RECEIPT DATE: 4/15/19 **ONSITE SEWAGE DISPOSAL SYSTEM** P 515360  
 APPROVAL DATE: 5/16/19 **PERMIT: CONSTRUCTION** A \_\_\_\_\_  
 PROPERTY ADDRESS: 13834 Mill Creek Court  
 SUBDIVISION: Crawford Subdivision LOT: 6 TAX ID: \_\_\_\_\_  
 CONTRACTOR: South Carroll Backhoe EMAIL: scbackhoe@comcast.com  
 CONTRACTOR ADDRESS: 4410 Salem Bottom Road, Westminster, MD 21157 PHONE: 410-596-3618  
 PROPERTY OWNER: NVR INC. EMAIL: \_\_\_\_\_  
 OWNER ADDRESS: 9720 Patuxent Woods Drive, Columbia, MD 21046 PHONE: 410-379-5956  
 SEPTIC TANK SIZE (GALLONS): 2000 TANK MANUFACTURER: Babylon  
 PUMP MODEL: N/A PUMP SIZE N/A PUMP TANK CAPACITY: N/A

**From:** Bernard, Dana  
**Sent:** Thursday, January 10, 2019 10:19 AM  
**To:** Kristy Pierce (kpierce@glwpa.com)  
**Subject:** 13834 Mill Creek Court Lot #6

ONSITE SEWAGE DISPOSAL SYSTEM DESIGN PLAN  
**CRAWFORD SUBDIVISION**  
LOT 6 (13834 MILL CREEK COURT)  
PLAT No. 24600-24607  
ELECTION DISTRICT No. 5  
HOWARD COUNTY, MARYLAND

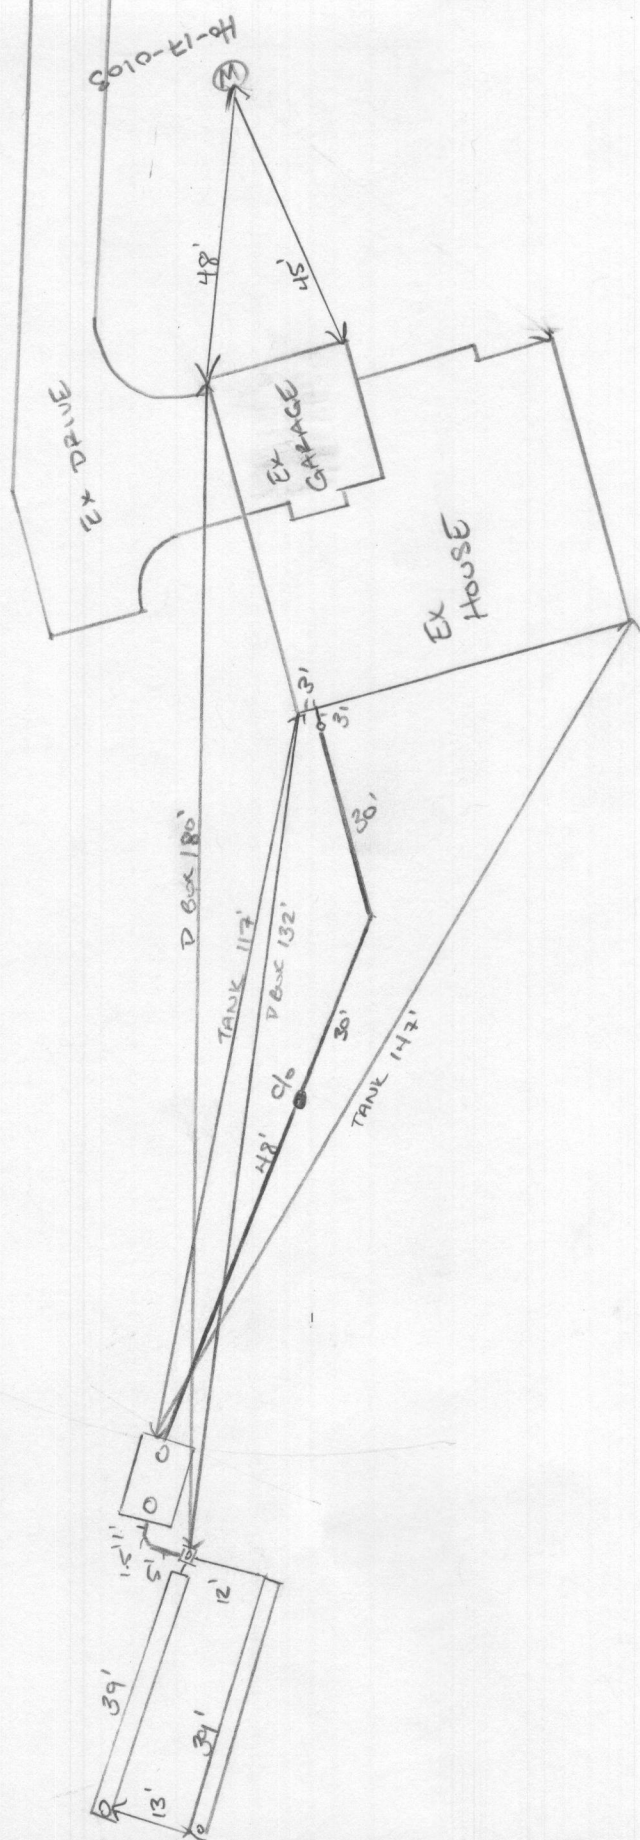
4/23/19 Met S. Carroll on site for layout. Tank and SDA corner stakes present. Shot contour and laid out upper trench at 37' and lower at 38'. A couple of trees to be removed prior to install. (SC)

INSTALLATION: 5/9/2019 SHC INSTALLED AND SEWER LINE DOWN TO TANK LOCATION. TANK ARRIVED AND TO BE SET. @ (PM VIA PHOTO) TANK SET. @ 5/16/2019 TRENCHES COMPLETED. D BOX LEVELLED WITH SPEED LEVELS. (C)

PIPE SPEC:  
4" SCH 40 PVC  
TRENCH STONE WAS GREAT.

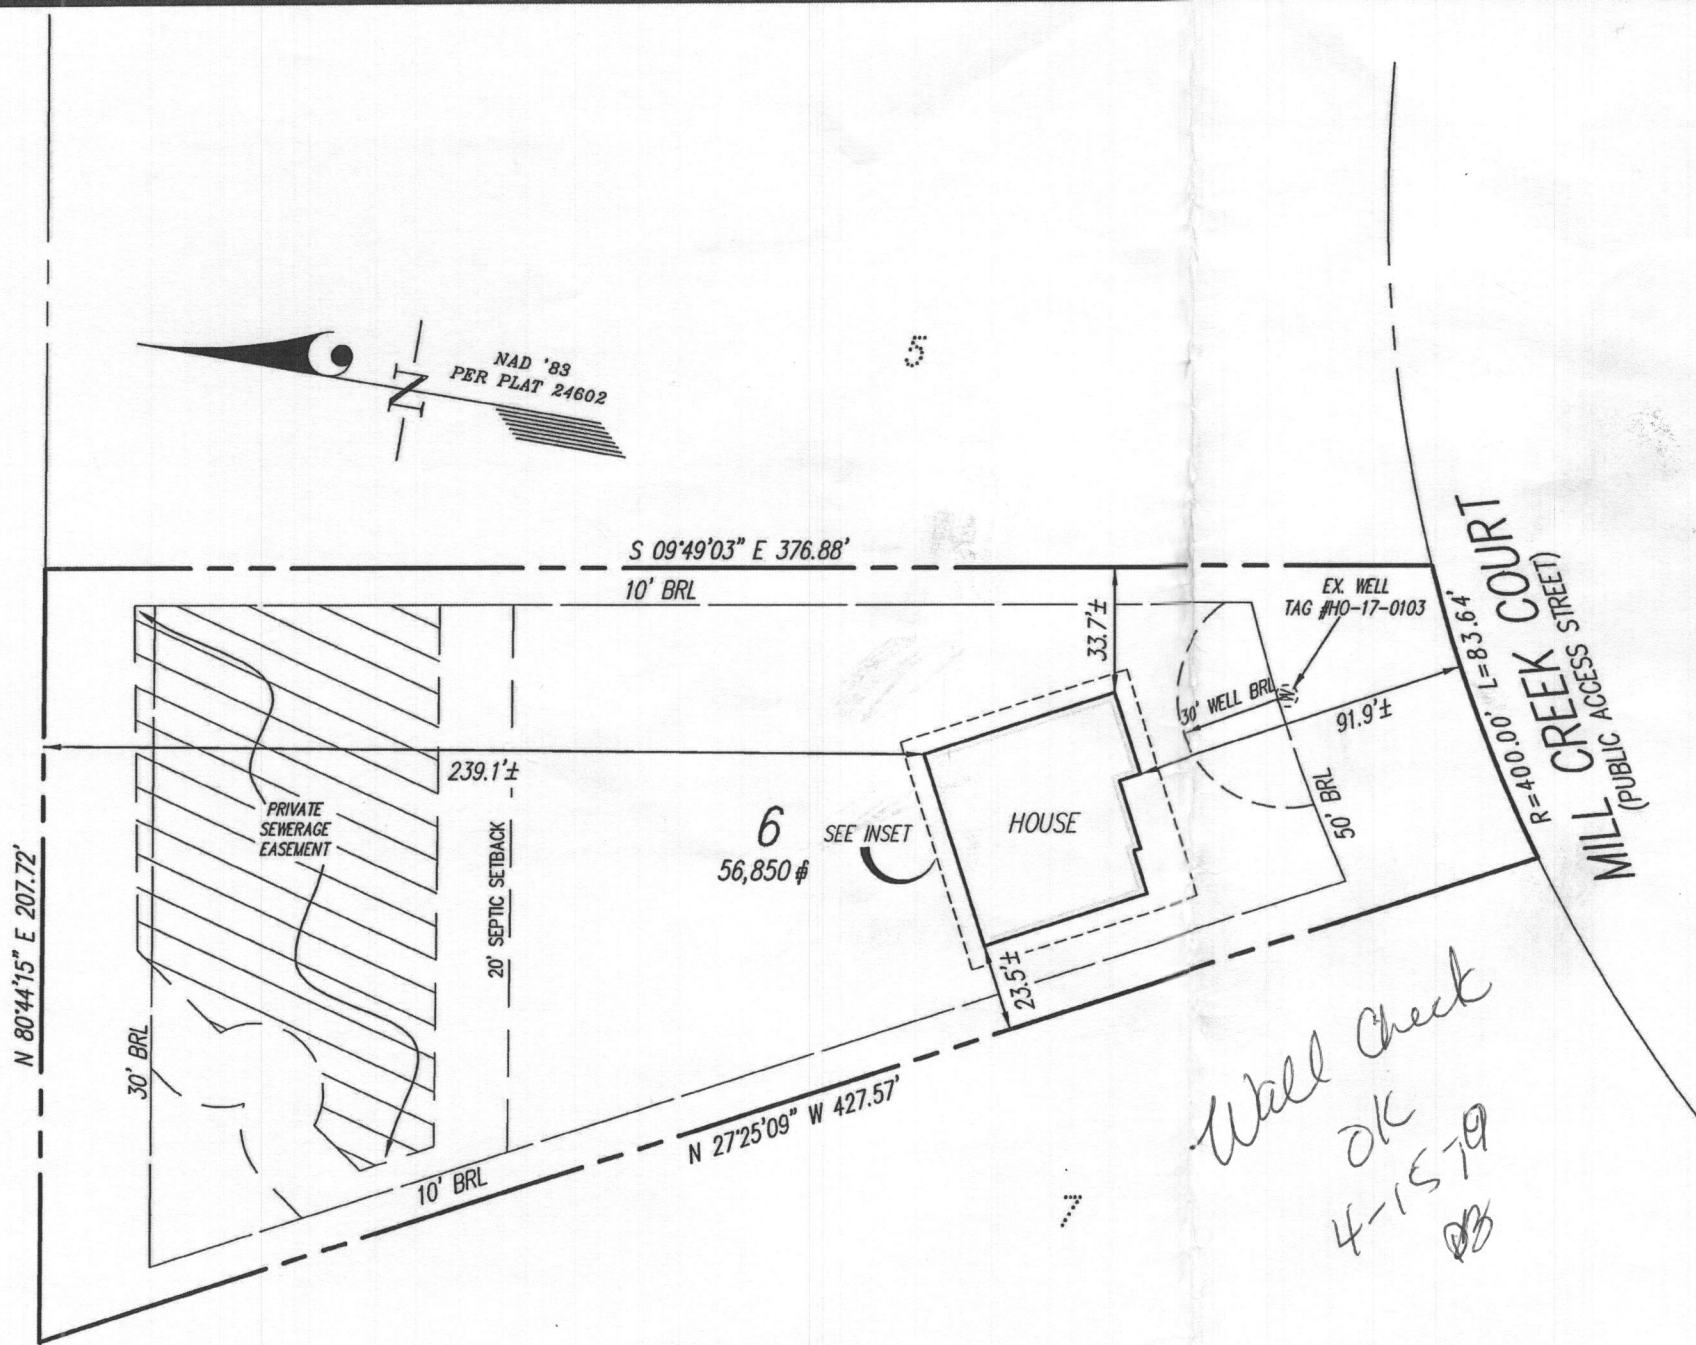
Lot 6 at 13834 Mill Creek OSDS plan has been approved. However, the location of the distribution box may not provide the most efficiency and may be adjusted in the field during the layout inspection.
